Addendum 9/02/2017

Figure 1: RC filter was added to the wake-up input.

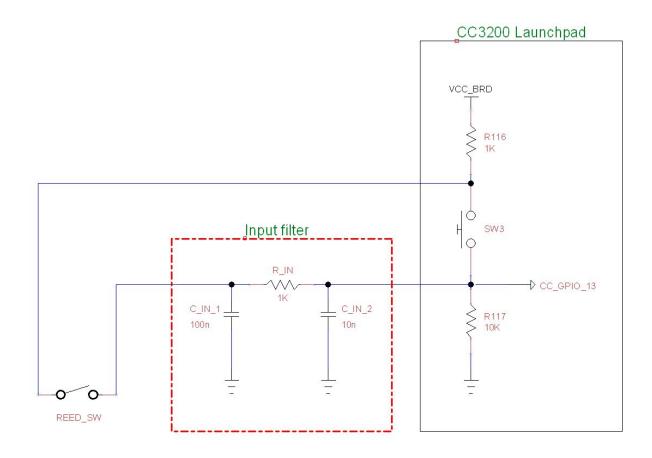
After deploying the device and observing for three months, it was noted that the red LED on the CC3200 board would occasionally turn on at the moment the sump pump turned off. This indicated that the board went through the POR due to an active wakeup input. As expected, the EMI blast from the pump was coupling on the input wire and generating a wakeup. Since the software debouncing is relatively long, the device would ignore this event and go back to hibernation. However, this could significantly impact battery life.

In any case, it is not good practice to have the input go directly to the microcontroller pin, so it was decided to add a RC filter to the input and see if that alleviated the problem before testing other ideas (TVS, ferrites, etc.). Adding 10nF, 100nF, and 1kOhm in pi configuration to the input (see schematic below) indeed did solve the issue. This would have been an appropriate addition in the initial design.
